ENVIRONMENTAL MINOR PROJECT CHANGE FORMProject Name: Banducci Substation Request Prepared By: TRCDate Approval Required: 8/10/17 Variance Request No: Minor Project Change No. 2Date Submitted: 8/8/17 Location: East side of Pellisier Rd. ROW near Dale Rd.Landowner: Public ROW and SCE land right¹ Landowner Parcel Number: N/A¹Current Vegetative Cover/Land Use: Unvegetated/Road ShoulderExisting Sensitive Resource? No Yes Specify: _____

MPC Request No. 2
Exhibit A: Minor Project Change
Description, Justification, and Analysis

Banducci Substation Project

Minor Project Change Request No. 2

Distribution Redline Drawing

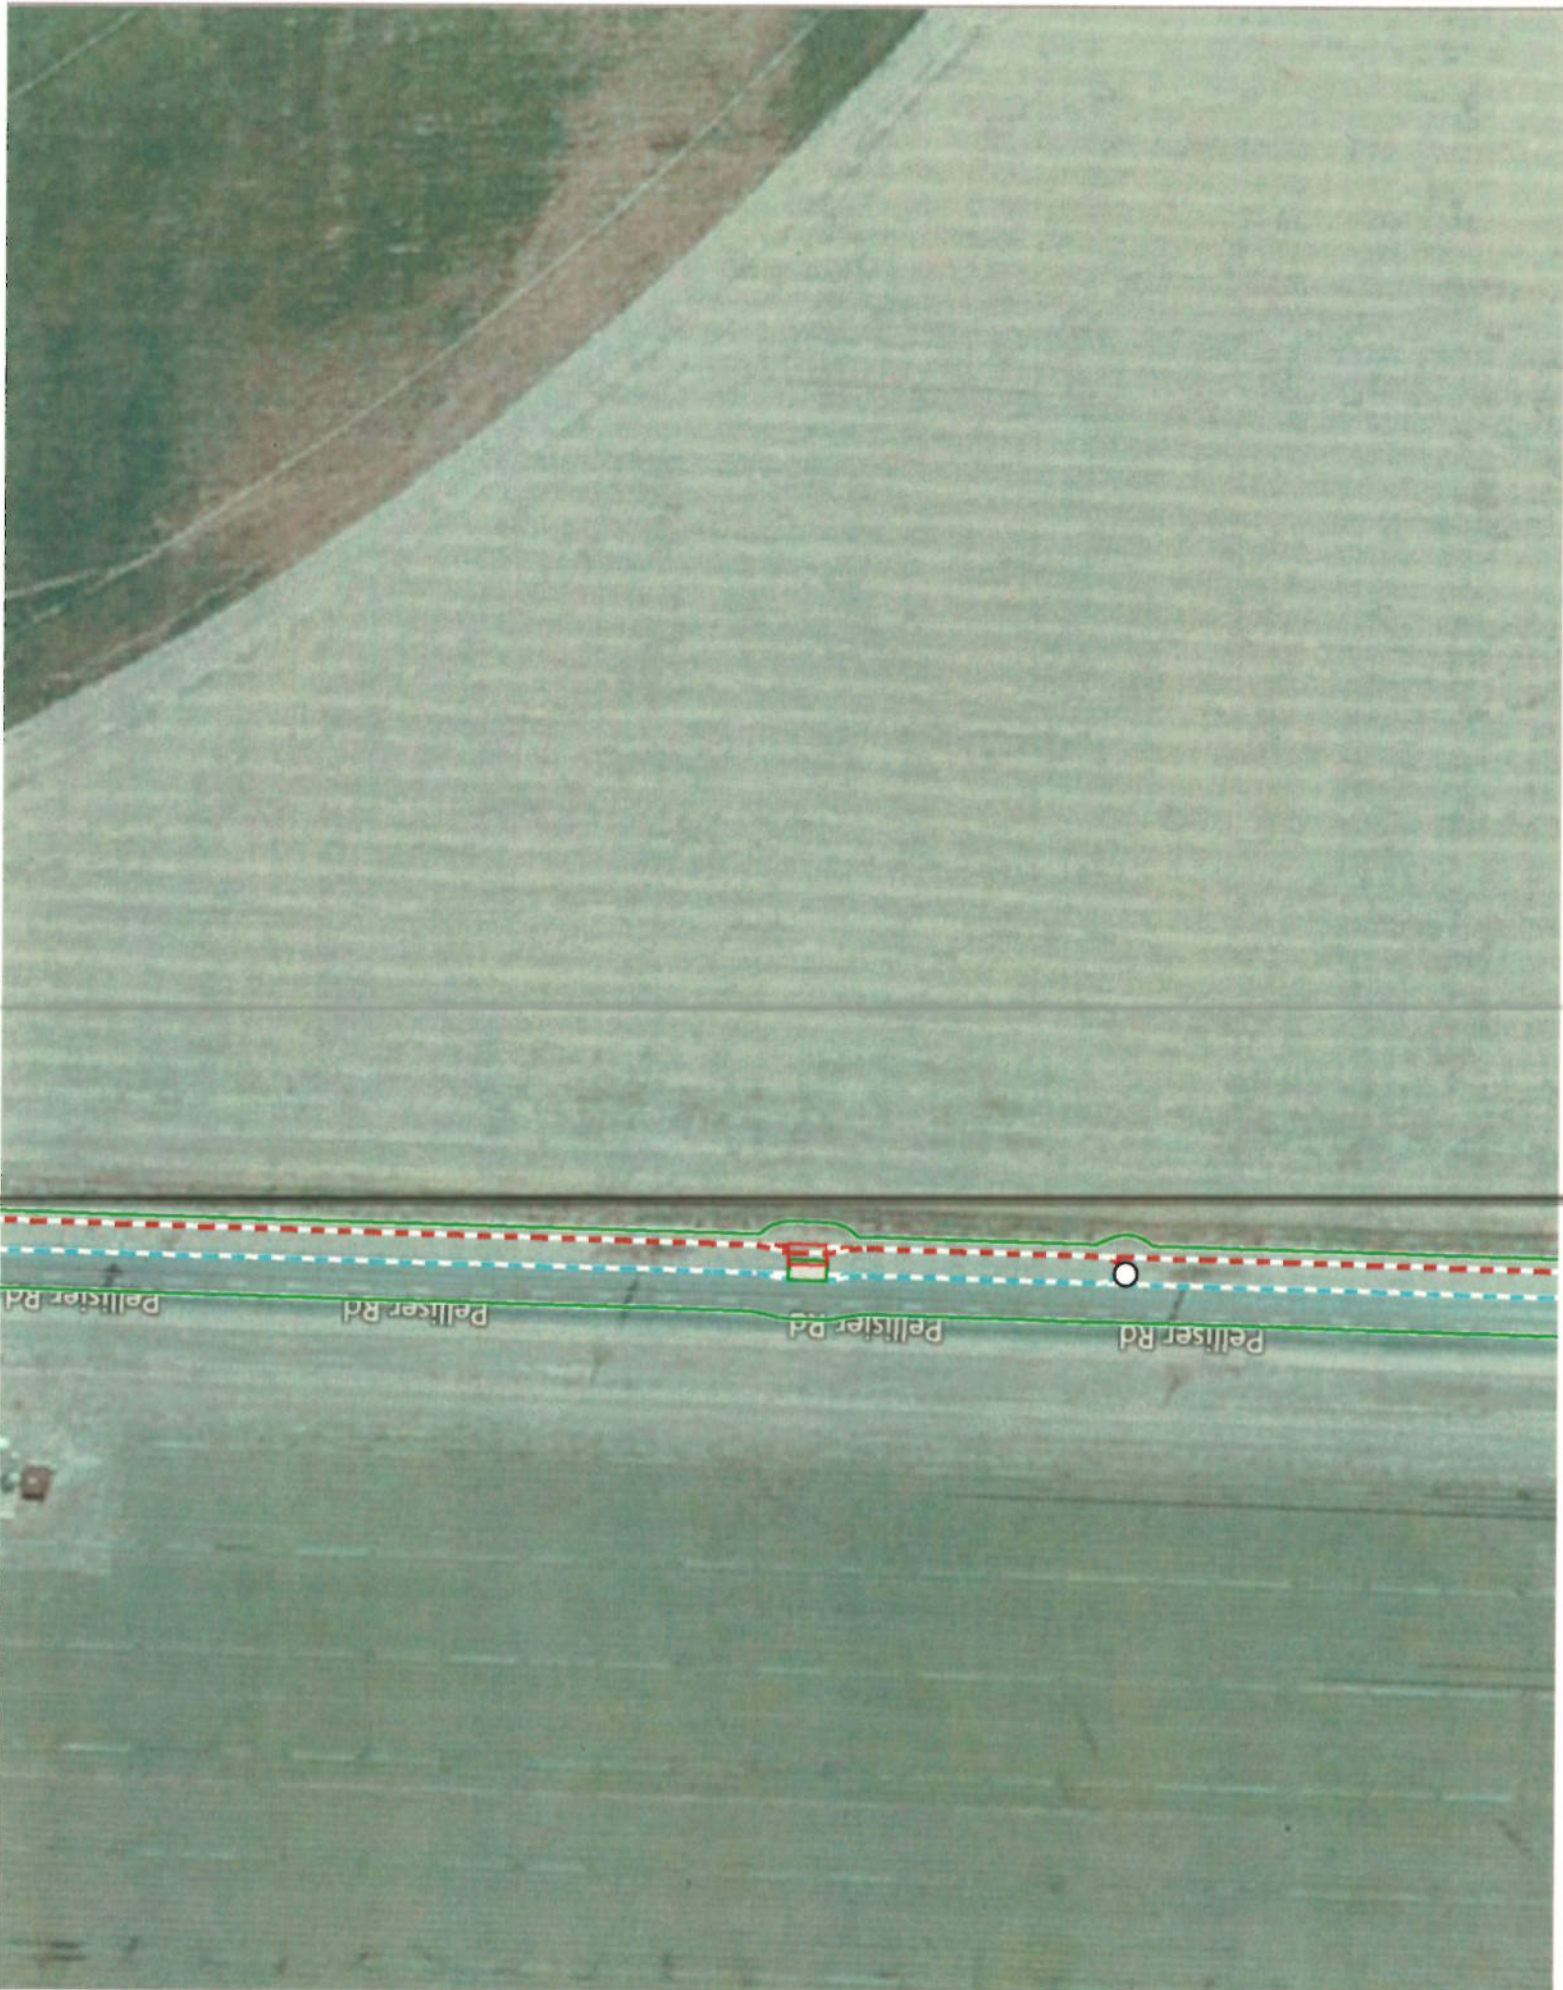
As part of pre-construction preparation, TRC identified the proposed distribution line alignment along Pellisier Road to have an unanticipated conflict with a preexisting buried AT&T telecommunication utility line. It was discovered that the AT&T utility line occurs within the same alignment proposed for the Banducci Substation Project distribution line segments that parallel Pellisier Road. As such, SCE proposes to modify the placement of the new distribution alignment, shifting the alignment approximately eight feet to the east of the approved alignment in order to avoid the potential for impact (e.g., damage or relocation) to the existing AT&T line. The adjusted relocation of the distribution line would remain on the east of Pellisier Road within the previously approved project LOD identified in the Final IS/MND and Notice to Proceed (NTP) Request No. 3. As described in the Final IS/MND, the distribution alignment would still parallel Pellisier Road from south of Dale road until terminating north of Highline Road. New vaults, pads, and required bore pits along the alignment would also be moved east, to be in line with the adjusted distribution line location, and vaults would be rotated 180 degrees at those locations where rotation would minimize the eastward shift in location. One bore receiving pit adjacent to Highline Road would be shifted both southward and eastward. Please refer to Attachment A: Distribution Redline Drawing, for a drawing showing the original and proposed distribution alignments. Attachment B contains site photographs that depict the locations of the AT&T utility, the approved distribution alignment, the proposed MPC alignment, and the approved LOD. The redlined location of the proposed alignment would be 19 feet from the Pellisier Road ROW centerline, which is one foot inside of the east edge of the Pellisier Road ROW.

The proposed MPC would not result in changes to geology and soils impacts as compared to those addressed in the Final IS/MND. The proposed MPC would shift the distribution line alignment approximately eight feet to the east of the approved alignment, within the approved LOD. The MPC alignment would be expected to encounter the same subsurface conditions and potential geologic hazards (e.g., liquefaction, seismic shaking, landslide potential) as described in the Final IS/MND for the approved project. Excavation and trenching activities would be identical to those described in the Final IS/MND and would not extend deeper or further than those previously described. Therefore, the proposed MPC would not result in any new potentially significant impact or substantially increase the severity of a previously identified impact to geologic or soil resources as disclosed in the Final IS/MND.

Photo 1: View north along Pellisier Road, showing approximate locations of the approved distribution alignment, the existing AT&T buried utility, and the proposed shifted distribution alignment.

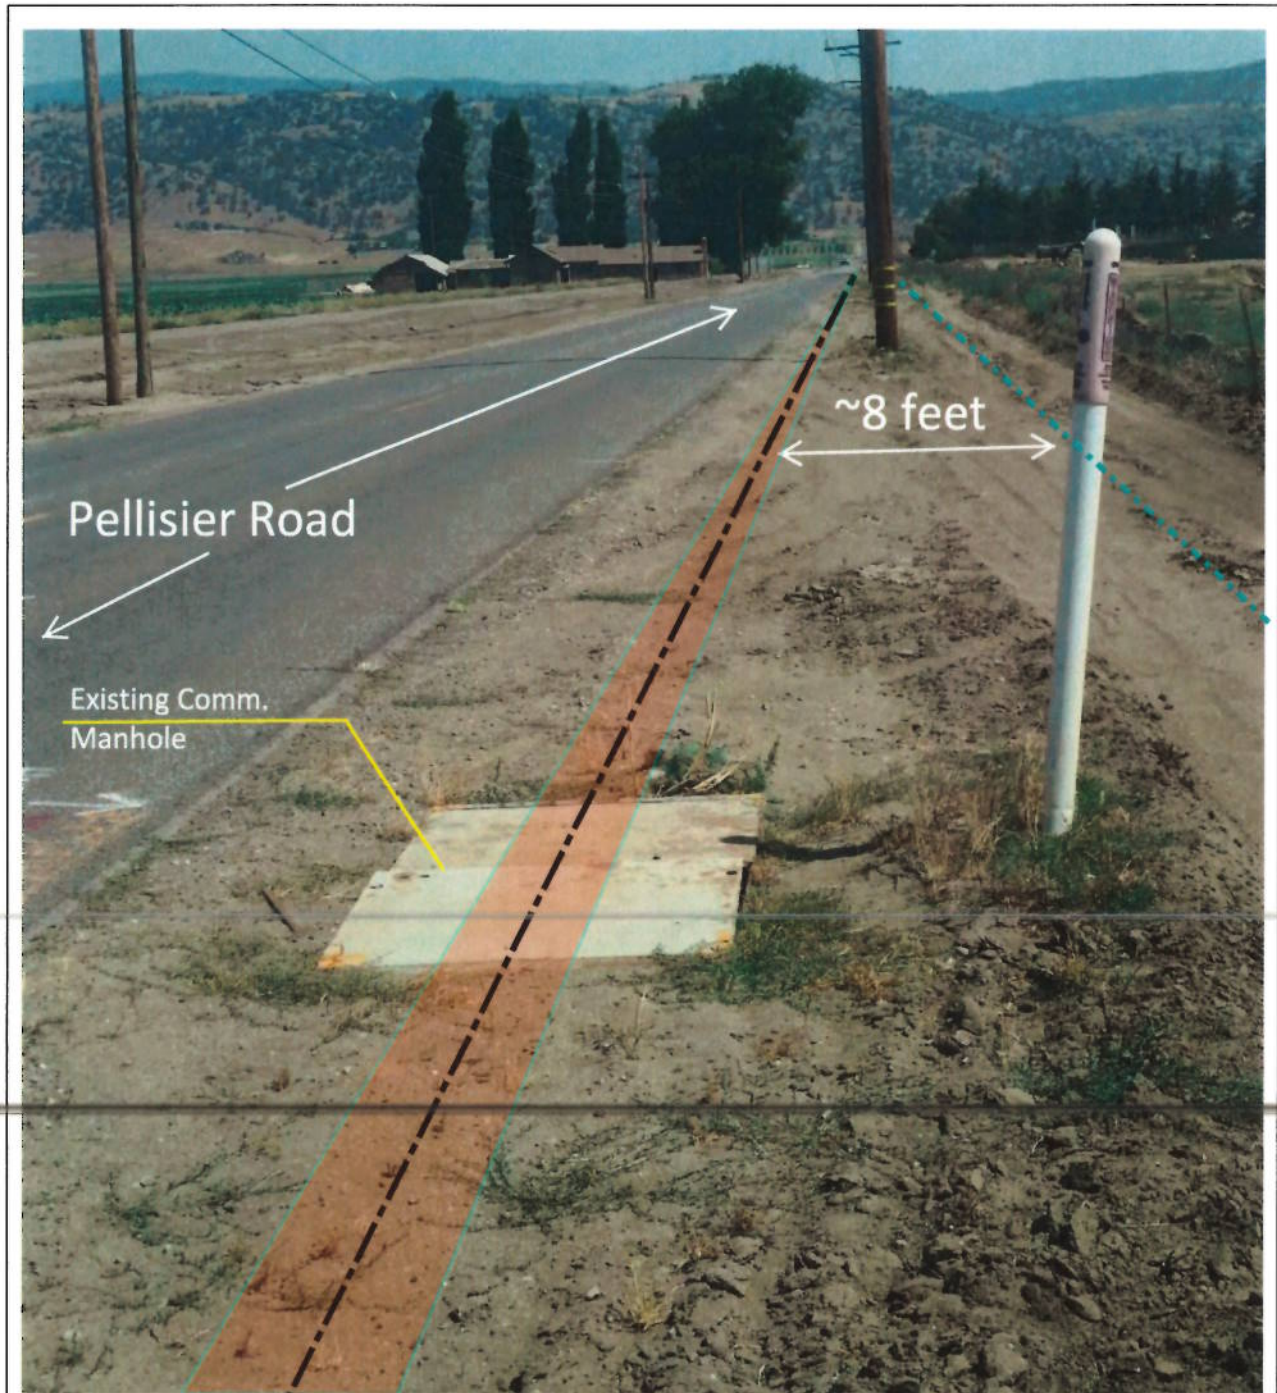
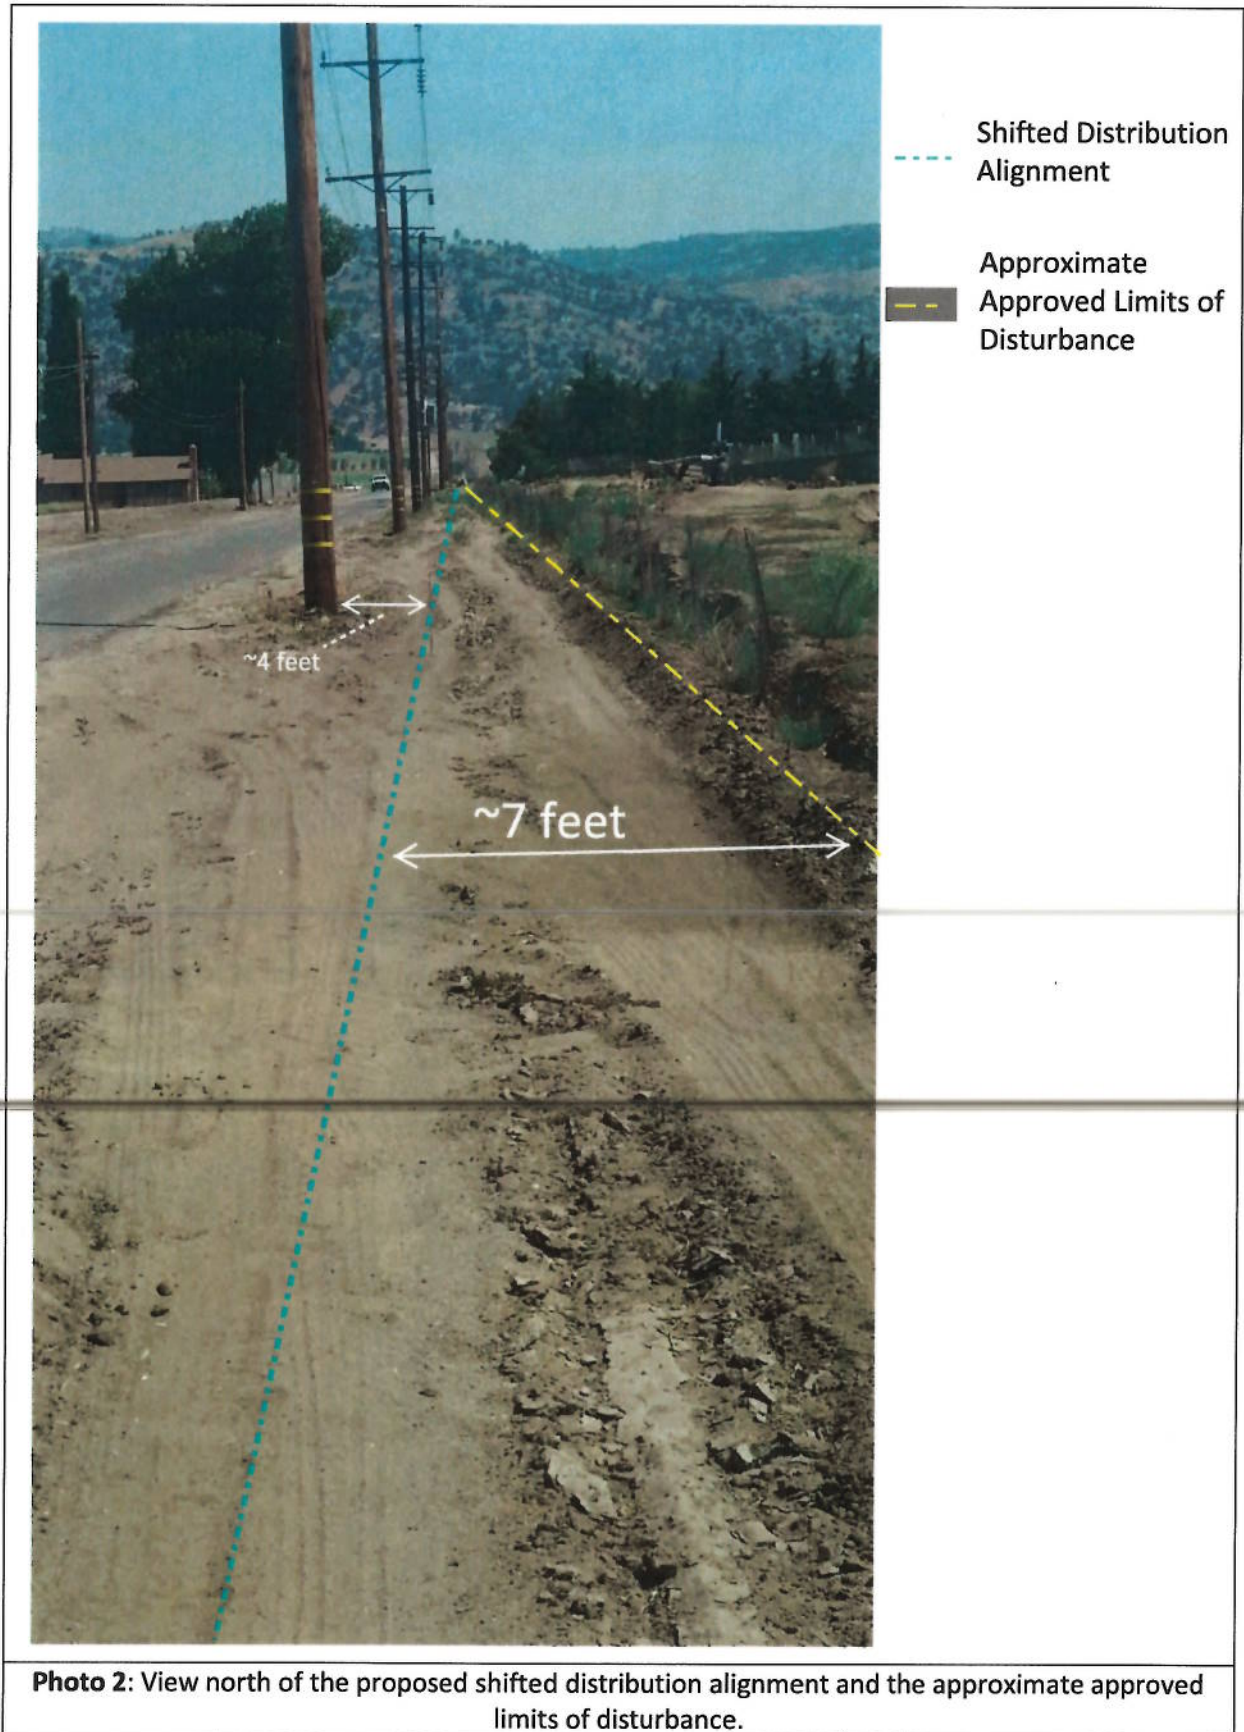
-  Approximate Approved Distribution Trench Line
-  Approximate Existing Comm. Line Alignment
-  Proposed Shifted Distribution Alignment
